TOWN OF NISKAYUNA
Planning Board and Zoning Commission

Agenda
August 28, 2023
7:00 PM

ITEM TITLE: DISCUSSION: 2837 Aqueduct Rd. (Rivers Ledge) – site plan app for a building containing 55 senior apartments and 2,000 sq. ft. of mixed-use commercial space.

Revised versions of a 13-page site plan and photo renderings of the proposed Sr. Center building and 4 covered parking garages were provided on 8/13/23. The majority of the PB's requests have been addressed in the new revision of the design, however a few action items remain unaddressed. A list of these items is included at the end of this Agenda Statement.

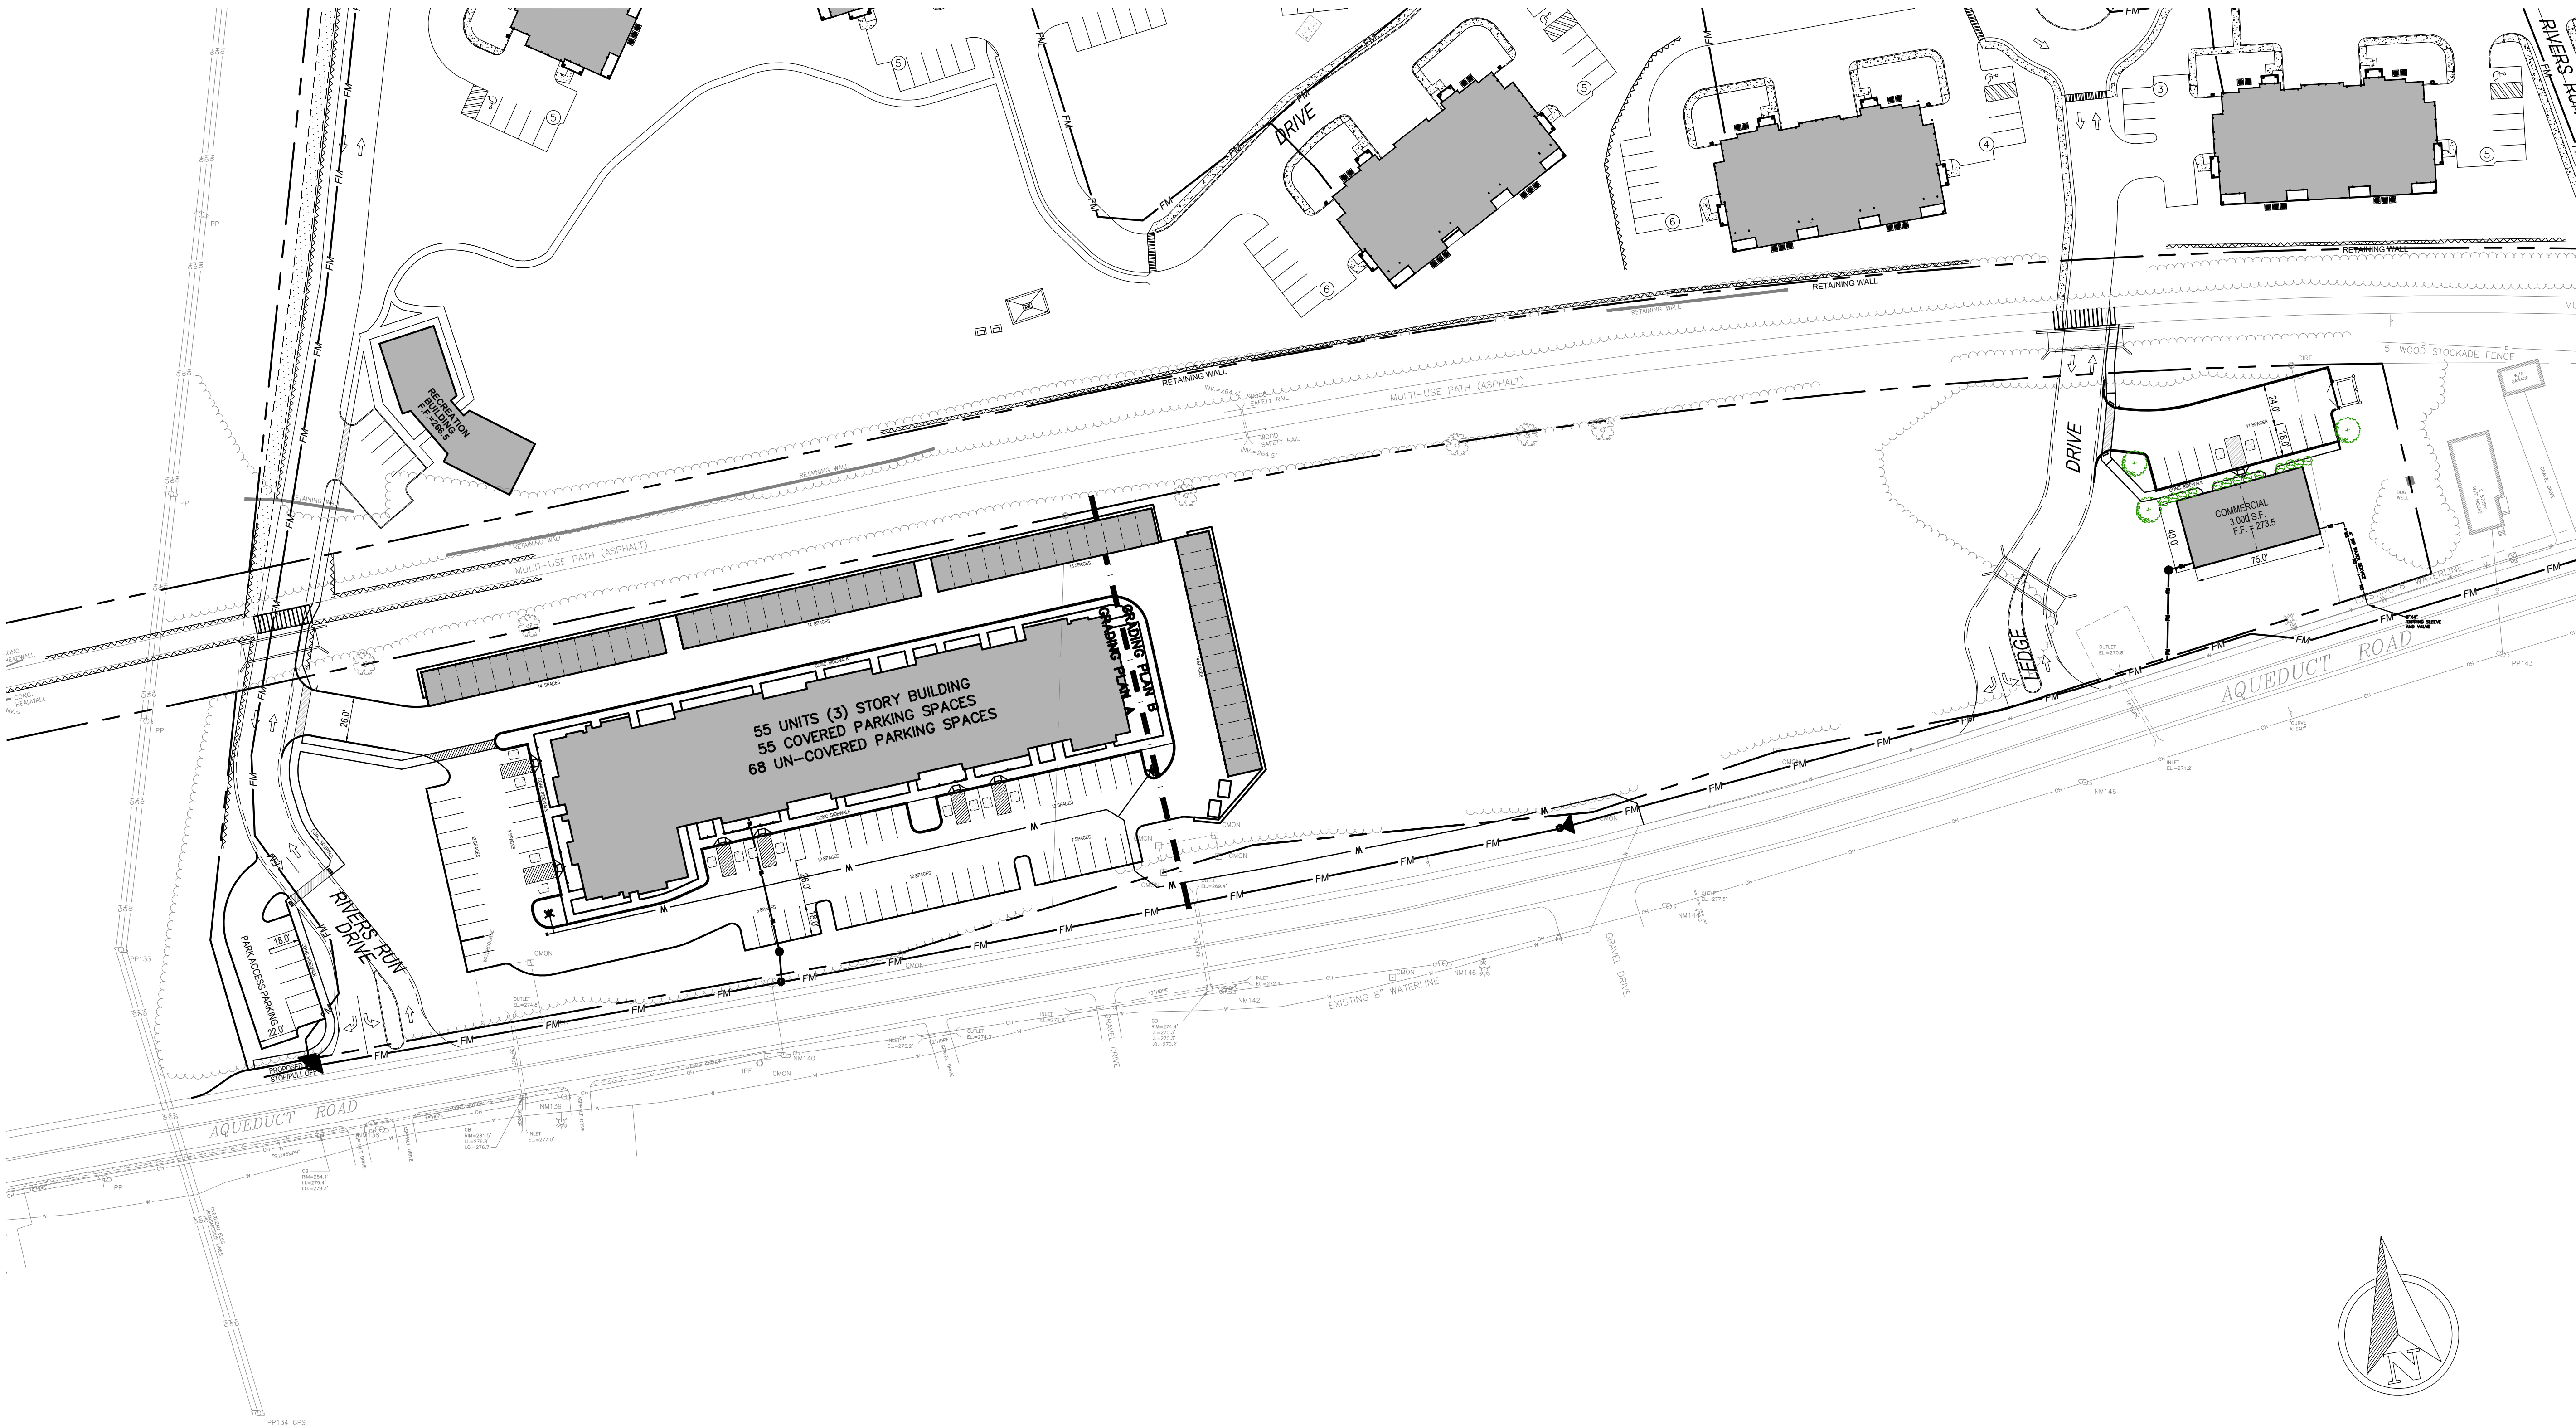
8/16/23 Architectural Review Board (ARB) meeting – The ARB reviewed the new files and documents. They were pleased with the overall appearance of the buildings and the surrounding landscaping. They provided Mr. Steenburgh with a marked up rendering and recommended

removing the courses of shingles under the gable roof portion of the garage. They also recommended that the gable feature be carried over to the back of the building.
